RE: Hillsborough County Southeast County Landfill
Facility Final Build-Out Conceptual Environmental Resource Permit Application
Response to Request for Additional Information
File No. 29-0270881-004

**SOUTHEAST COUNTY LANDFILL
FACILITY FINAL BUILD-OUT
CONCEPTUAL ENVIRONMENTAL
RESOURCE PERMIT APPLICATION**

RESPONSE TO REQUEST FOR ADDITIONAL INFORMATION

**RESPONSE TO FDEP
REQUEST FOR ADDITIONAL
INFORMATION**

**STORMWATER MANAGEMENT PLANS
POND B**

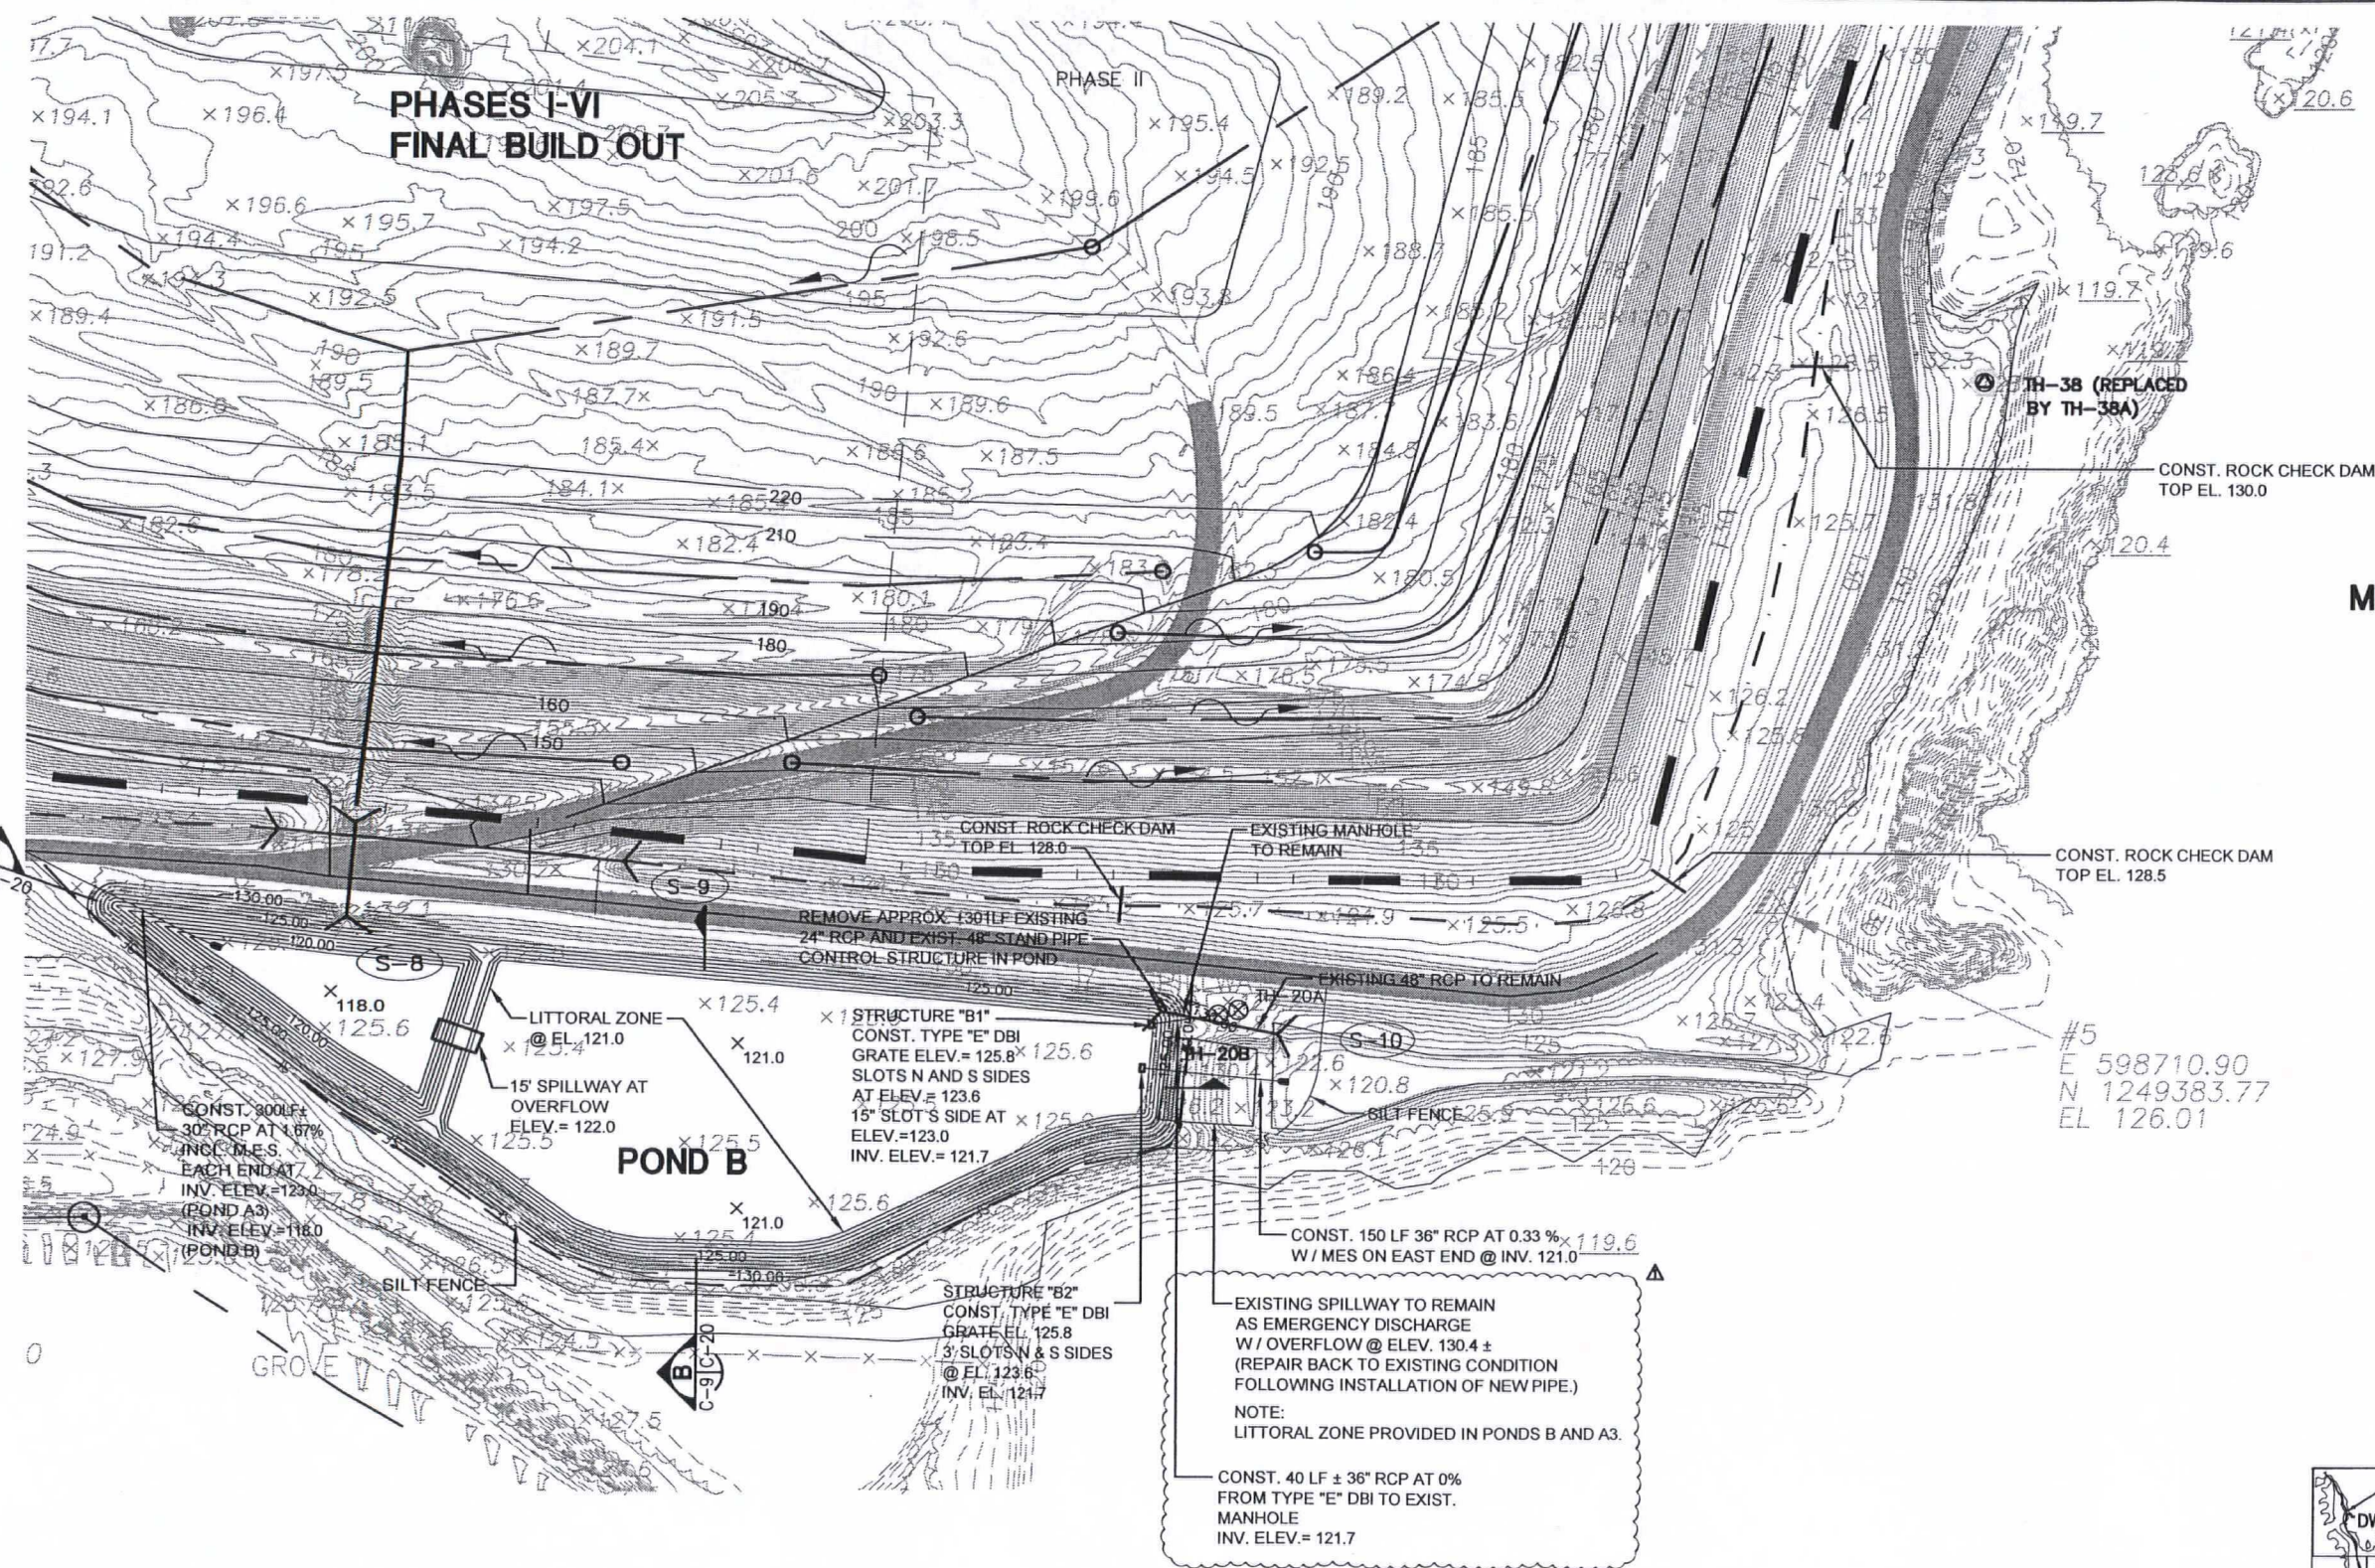
Comment 5: Please check all tables and the ICPR for consistency. For example, Pond B Strs. B1 and B2 on DWG 9 at 126.5', but DWG 21 table has 126.3'.

Response 5: The inconsistency noted has been corrected. We have re-checked all tables, models, and plans accordingly. The Revised Drawings 9 and 21 are provided in Attachment 1.

STORMWATER MANAGEMENT PLANS
POND D AND POLISHING PONDS

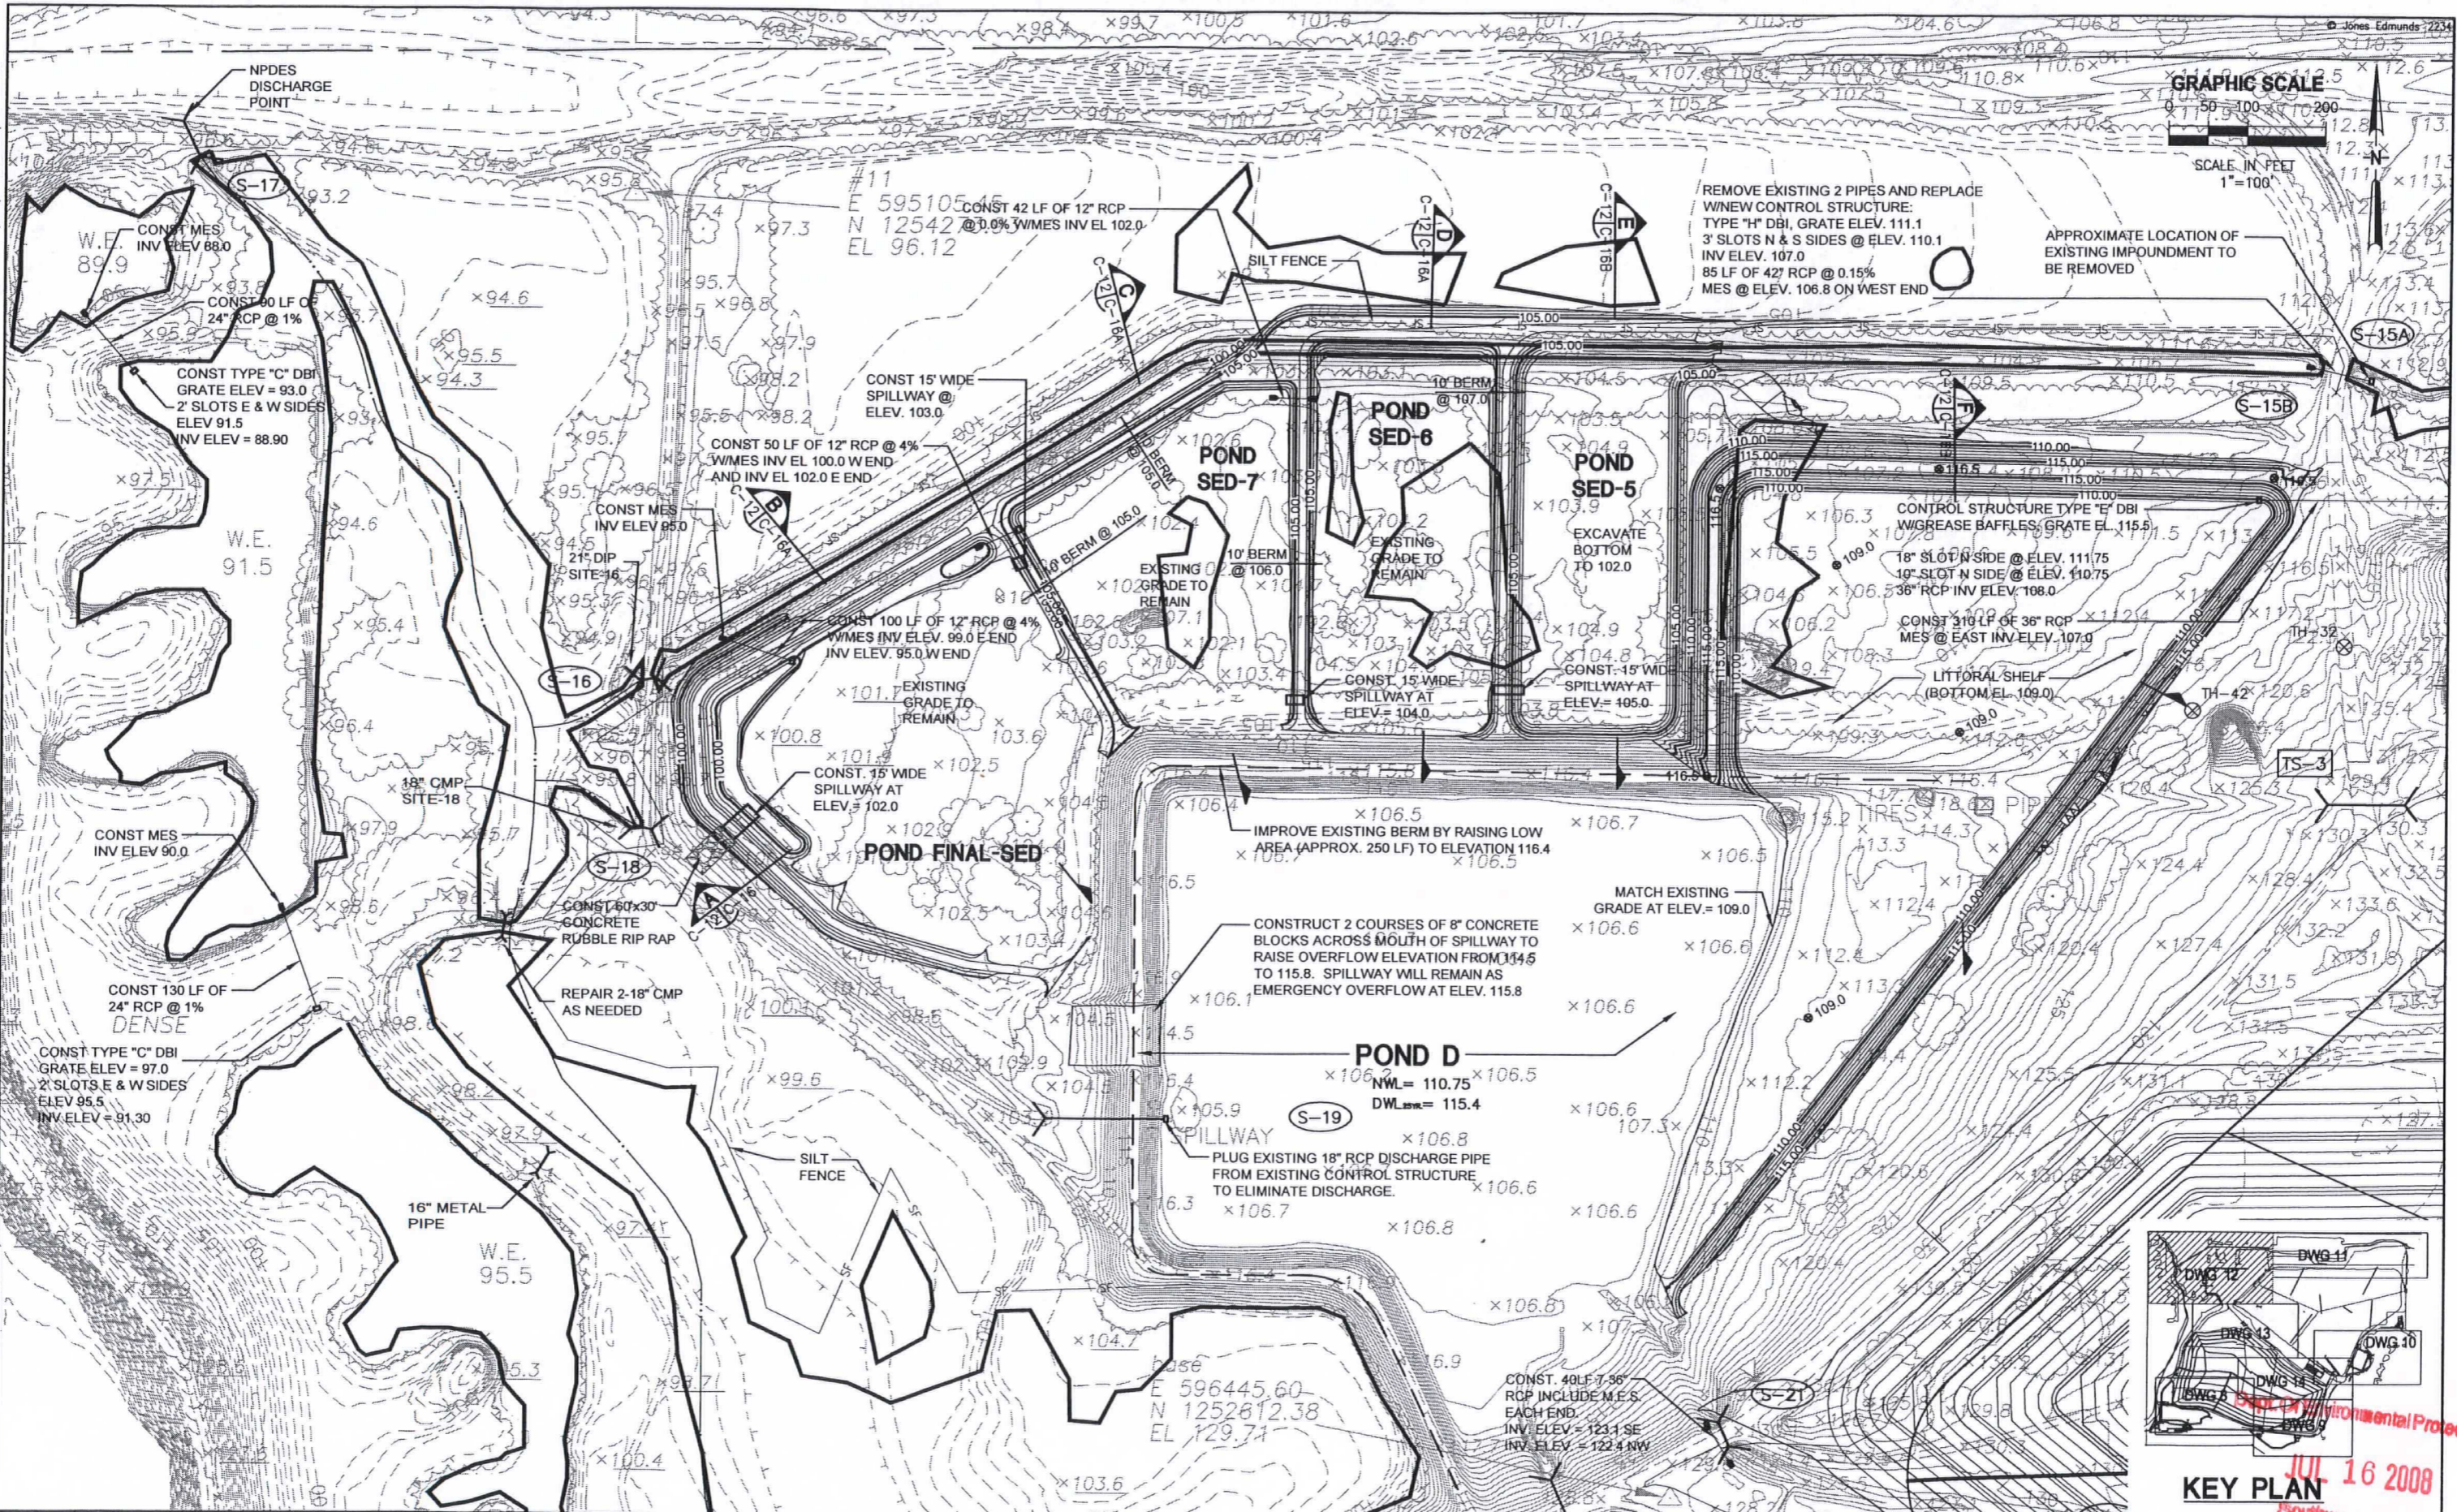
The Sed 5 wetland creation mitigation plan consists of a wetland vegetative cover (both plantings and natural recruitment) of the littoral areas below the identified control elevation – 105 (Figure 6.1 and DWG No. 12). Desirable herbaceous wetland species including bulrush (*Scirpus californicus* or *S. validus*) fire flag (*Thalia geniculata*), arrow-head (*Sagittaria lancifolia*), pickerelweed (*Pontederia cordata*), prairie iris (*Iris hexagona*), spatterdock (*Nuphar lutea*), and water lily (*Nymphaea odorata*) will be planted on 3-foot centers to establish desirable native species and to minimize establishment of exotic or nuisance species. Substitution of similar wetland vegetation is allowed with prior approval. All wetland species will be at least 4-inch pot minimum or equivalent. In addition, no individual plant species will exceed 33% of the required planting units without prior authorization (i.e., individual species cannot exceed 4,473 units).
